ADDENDUM No. 1

TO INVITATION TO BID No. 2022C041

DATE ISSUED: September 30, 2022

TITLE: Loussac Library Training Room

SHEET NO:
G102

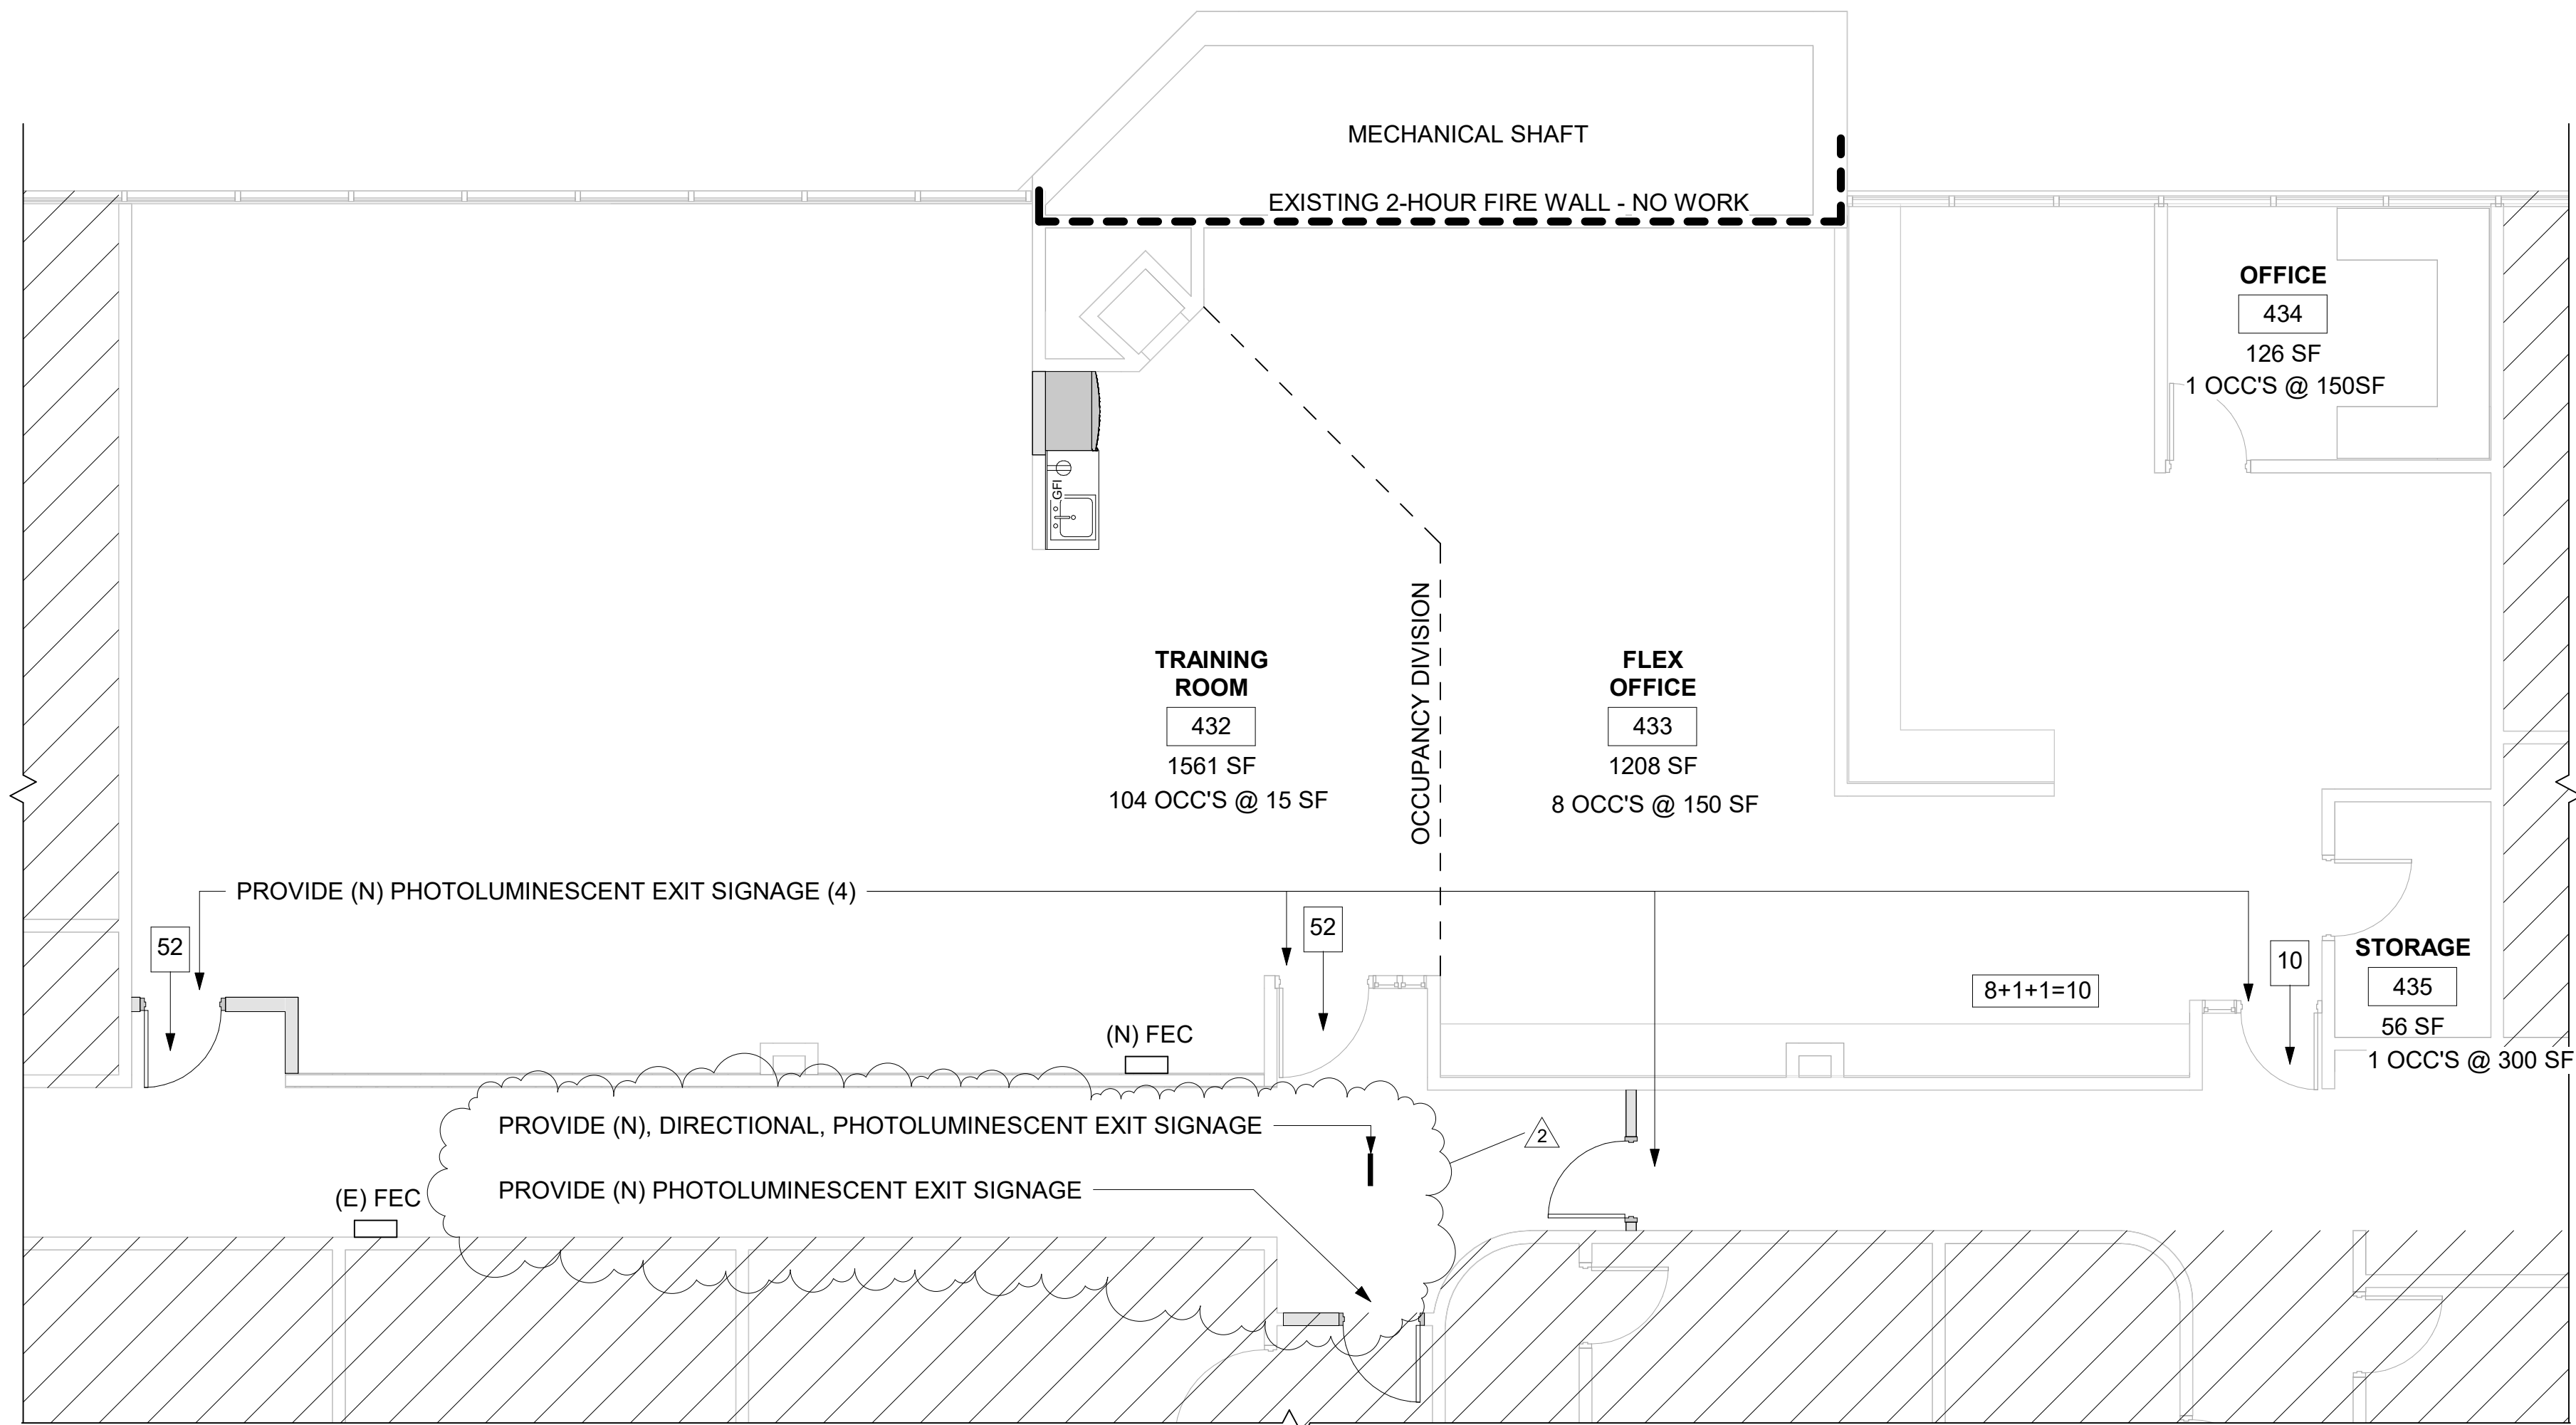
1. **Question:** How many new exit signs will be required for this project?
Response: See revised Sheet G102. Two (2) exist signs will be added to the current count required.

Response: If the contractor elects to extend stud framing to deck, the kickers reference above can be omitted.
3. **Question:** How many new exit signs will be required for this project?

Response: See revised Sheet G102. Two (2) exit signs will be added to the current count required.
4. **Question:** Can the Elevator be used to move material to and from the project location

SHEET NO:
A201

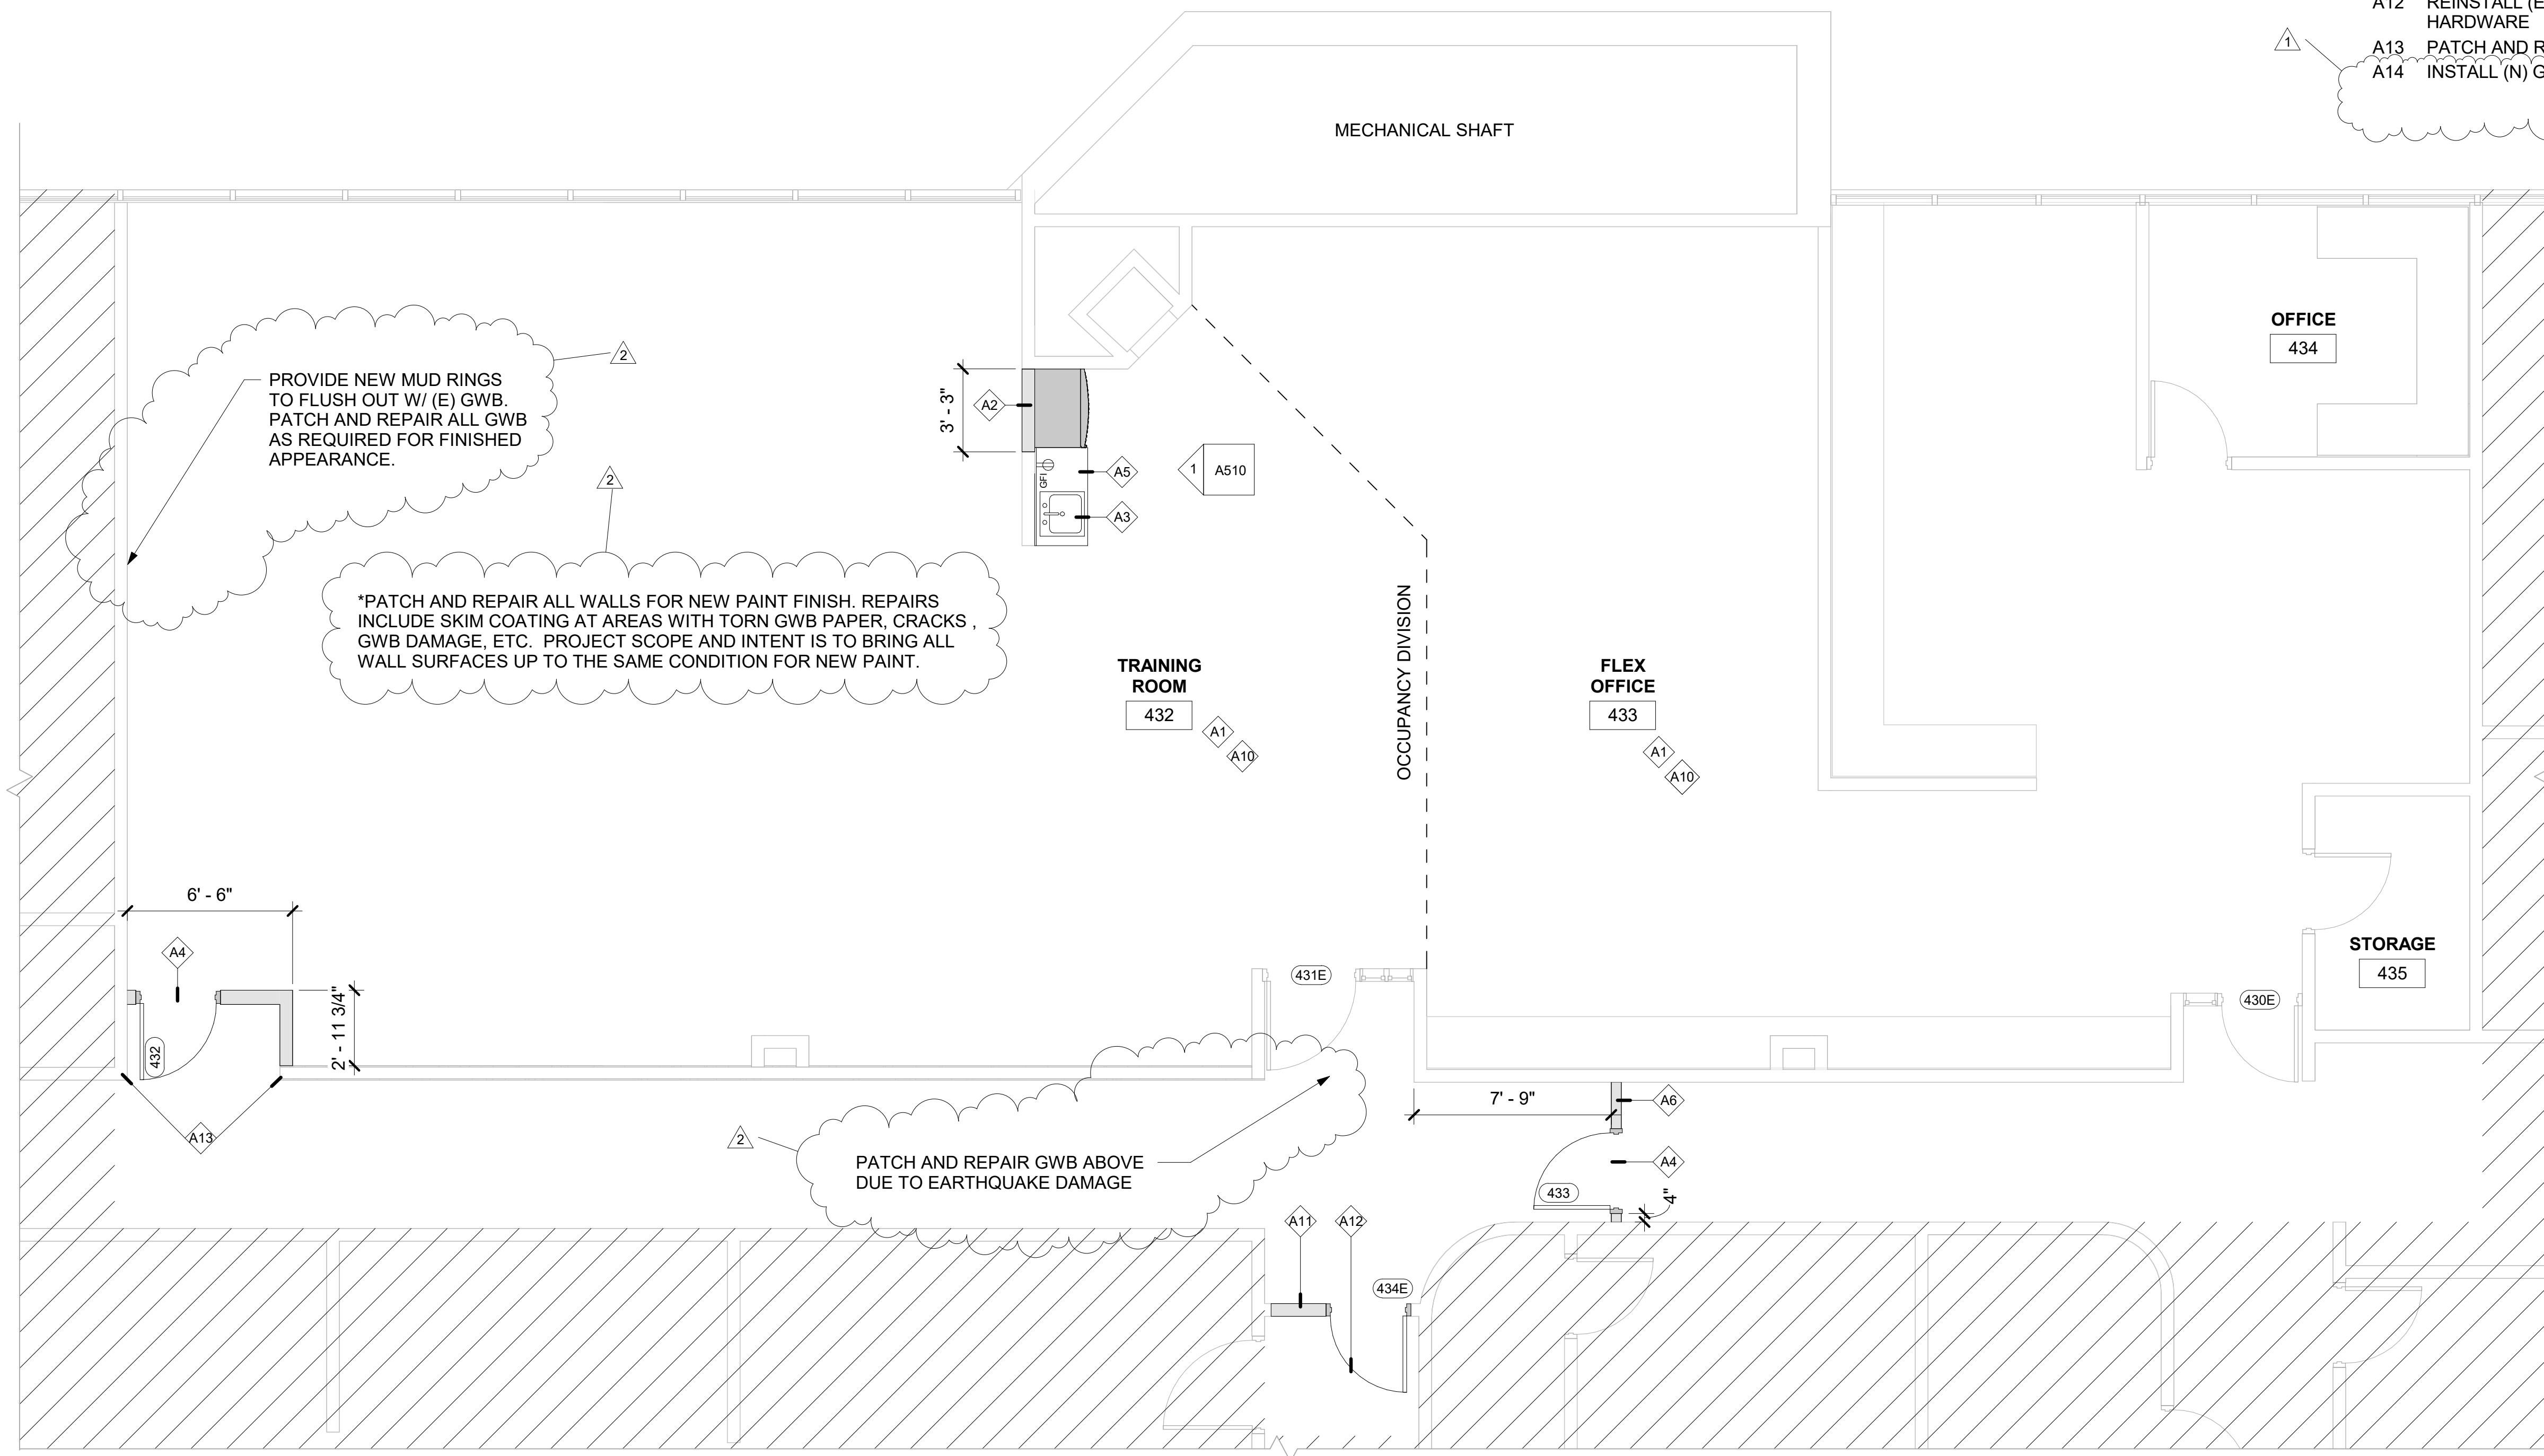
6. **Question:** Is the repair of the quake damaged drywall in the corridor soffit part of the scope of this project?
Response: Yes. See revised note on sheet A201.

9. **Question:** There are many areas of existing GWB substrates that are damaged for previous demo of existing wall mounted items. Please confirm the level of repair for all existing GWB substrates.

Response: See revised note on sheet A201 that reads as follows: PATCH AND REPAIR ALL WALLS FOR NEW PAINT FINISH. REPAIRS INCLUDE SKIM COATING AT AREAS WITH TORN GWB PAPER, CRACKS , GWB DAMAGE, ETC. PROJECT SCOPE AND INTENT IS TO BRING ALL WALL SURFACES UP TO THE SAME CONDITION FOR NEW PAINT.

A801

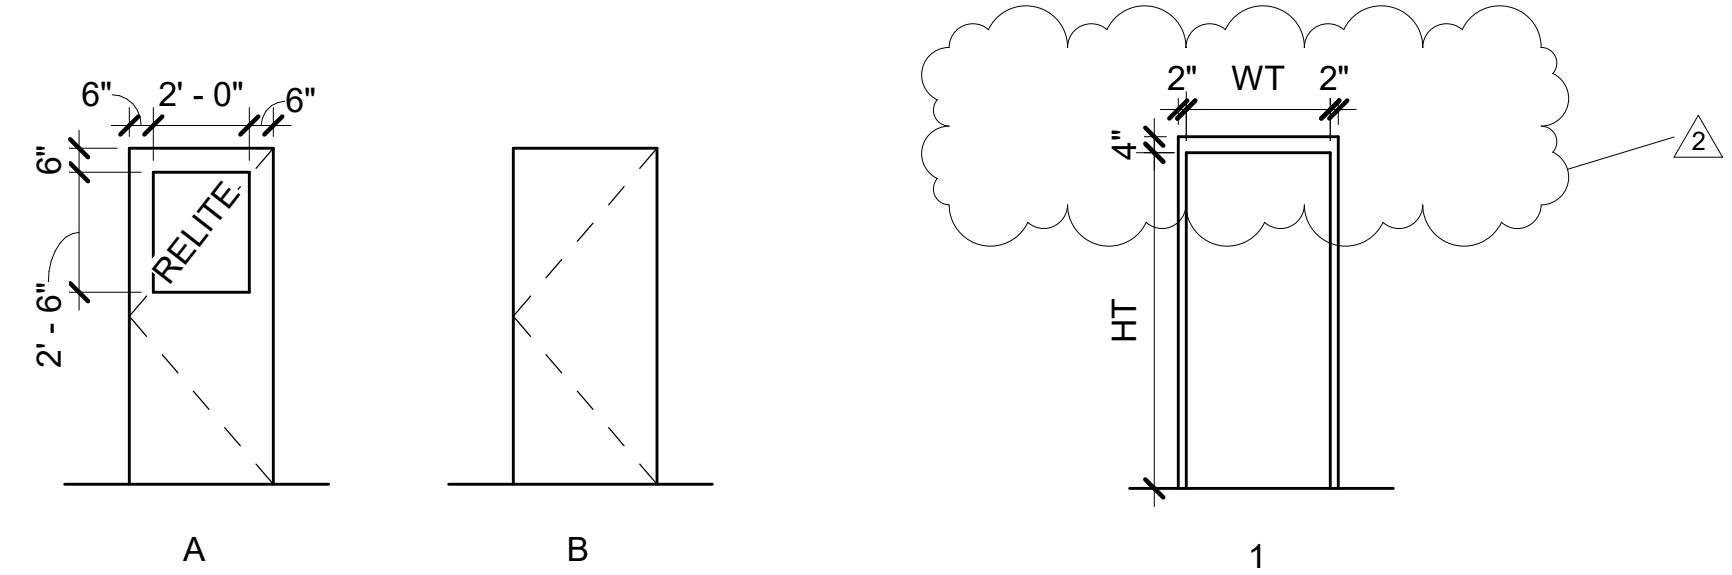
13. **Question:** For consistency and aesthetics, should the new hollow metal frames be provided with 4" heads to match the other frames in this area?

19. Question: Per the door schedule on page A801. None of the new openings have a rating assigned to them. Is this the design intent? If a rating for door (432) is required, the large relite will be very expensive.

Response: Provide all new door with 4-inch heads to match the existing, see revised sheet A801

Response: None of the new doors are required to be fire rated.
